Subject: 10CFR21 Reporting of Defects and Non-Compliance -
Engine Systems, Inc. Report No. 10CFR21-0085, Rev. 0

EMD Engine-Driven Water Pump Assemblies

Report No. 10CFR21-0085
Rev. 0: October 04, 2002

COMPONENT: Engine Water Pumps
EMD P/N 40089540, 40089541, 40089881, 40089882

FIGURE 1
Water Pump Cross Section

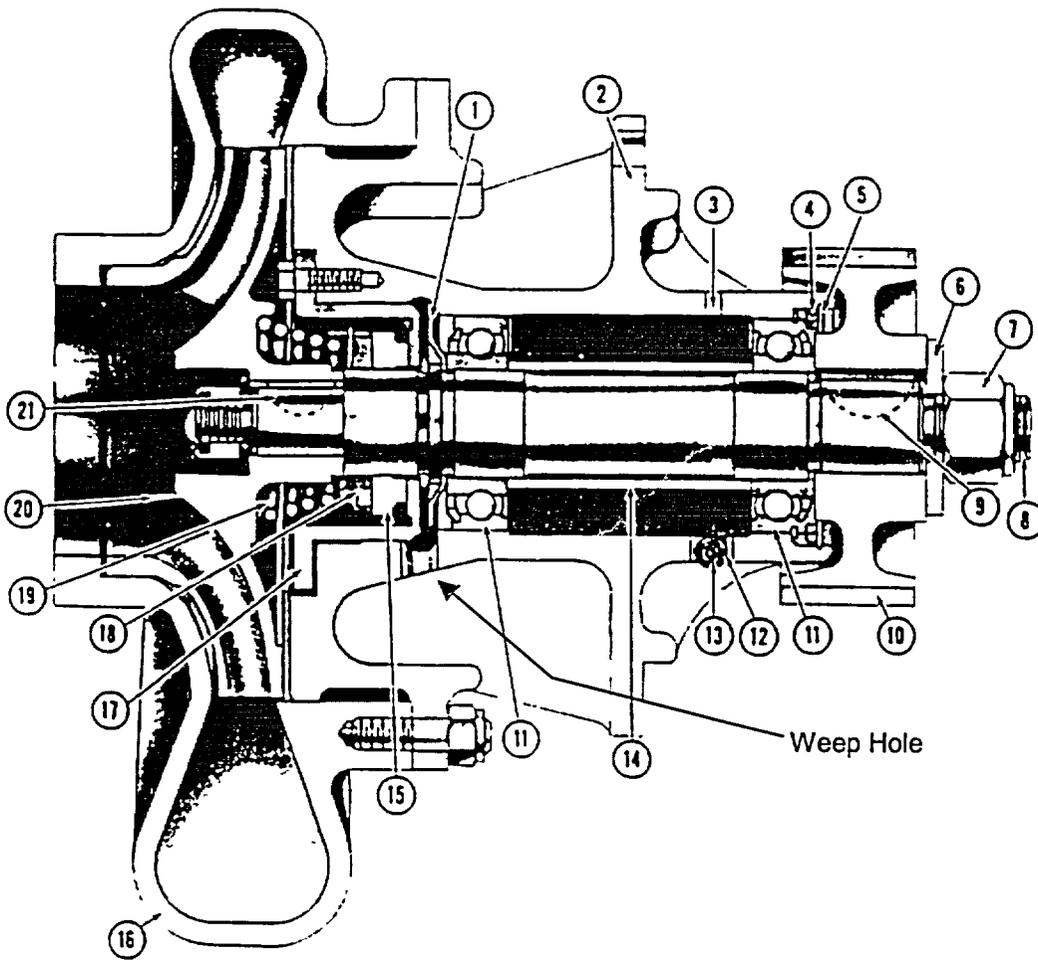
A cross-sectional view of the EMD standard water pump is shown in Figure 1 of this report.

The water pump impeller and shaft assembly is supported in the housing by two roller bearing assemblies, item 11. The bearings are lubricated by splashed engine lube oil entering through the inlet hole, item 3, located in the top of the drive end of the support housing. Oil exits the bearing cavity through the oil outlet hole, item 12, located in the bottom of the drive end of the support housing. The cooling water is sealed through a mechanical seal assembly located at the impeller end of the shaft assembly, items 15, 17, 18 & 19. The cavity between the bearings and mechanical seal contains a drilled passage (weep hole) to provide an external visual indication of leakage of water from the mechanical seal as well as to prevent water from contaminating the bearings and engine oil system.

In an effort to extend the service life of the water pump assemblies, EMD redesigned the bearings, shaft and support housing to utilize tapered roller bearings in lieu of spherical roller bearings. The tapered roller bearings were mounted as opposed pairs in a back-to-back arrangement. A seal was installed at the opposite-drive end of the shaft to prevent oil leakage into the cavity and out the weep hole. This modification was incorporated on all water pumps applicable to 16 & 20 cylinder EMD engines. The earlier design pumps utilizing spherical bearings were discontinued in April, 2000.

Through the locomotive and marine industry, EMD has found that the redesigned pumps are experiencing premature failures of the internal seals resulting in leakage via the weep hole. The primary leaking fluid is engine cooling water, however, leakage of lubricating oil from the bearing side is a possibility. The seals are failing as a result of an insufficient preload on the tapered roller bearings. Without adequate preload, there exists excessive clearance between the rollers and race. This clearance results in chattering of the rolling elements and relative movement of the shaft within the pump. The issue applies to the design of the pump assembly relating to establishing and maintaining adequate preload on the bearings during operation. The problem is not a result of incorrect assembly.

No method is available to indicate the condition of the seals within the water pump assembly. The service history of the pumps with tapered bearings has indicated the seal failures occur either immediately or prematurely after a low number of operating hours. It is for this reason that it is recommended to replace the tapered bearing pumps with the previous design units using standard roller bearings.

Replace the tapered roller bearing water pump assemblies with standard roller bearing water pumps as identified below. Use the leakage rate (if present) as an indicator of the urgency of pump replacement. If no leakage is present, continue with monthly leak inspections and replace the pumps at the next available opportunity.
